MIL-PRF-19500/478G
AMENDMENT 2
12 January 1999
SUPERSEDING
AMENDMENT 1
21 November 1997

SEMICONDUCTOR DEVICE, DIODE, SILICON, POWER RECTIFIER, FAST RECOVERY
TYPES 1N5812, 1N5814, 1N5816, AND R VERSIONS
JAN, JANTX, JANTXV, JANHC, JANKC, AND JANS

FIGURE 1. Physical dimensions (DO-4).

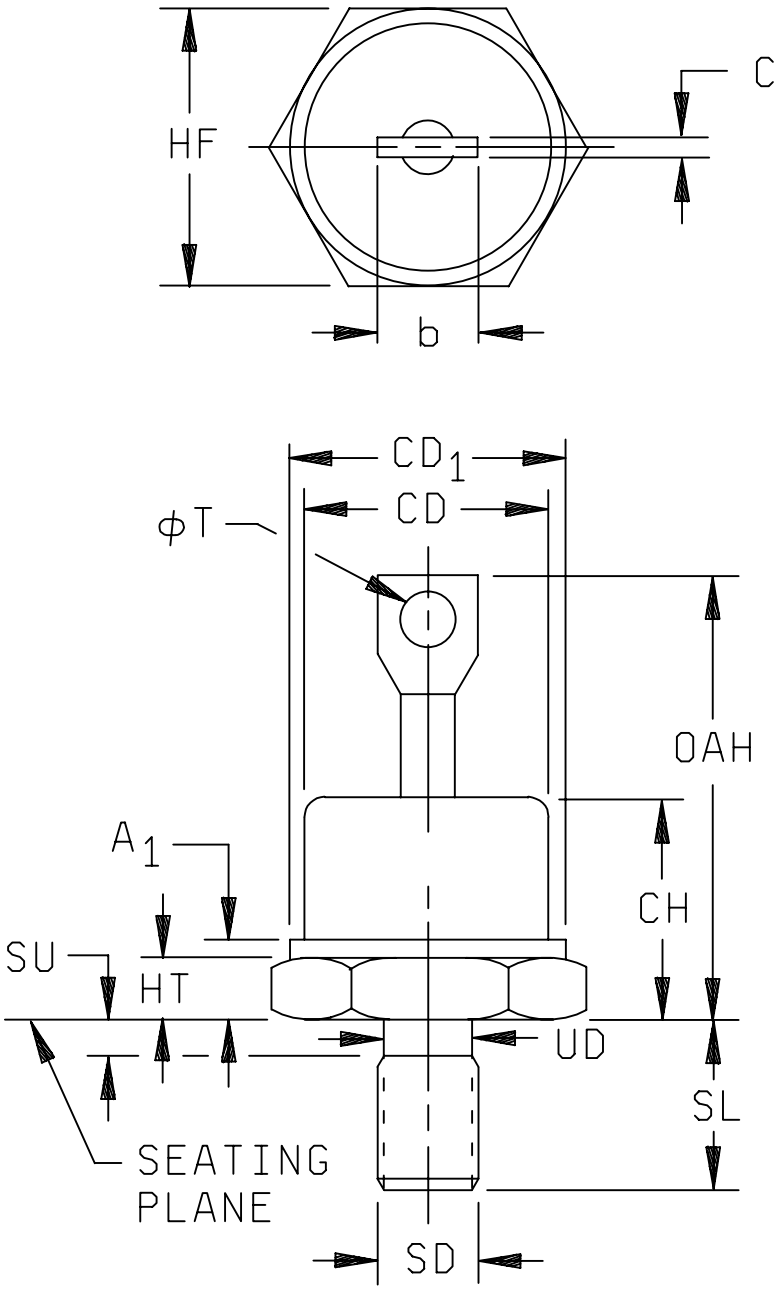
* Figure 1, dimension table, delete letter CD in its entirety and substitute

" | CD | 0.265 | 0.424 | 6.74 | 10.77 | |"

* Figure 1, dimension table, delete letter CD• in its entirety and substitute:

" | CD_1 | 0.265 | 0.437 | 6.74 | 11.10 | |"

* Figure 1, dimension table, add letter b at end of table.

" | b | | 0.250 | | 6.35 mm | 4 |"
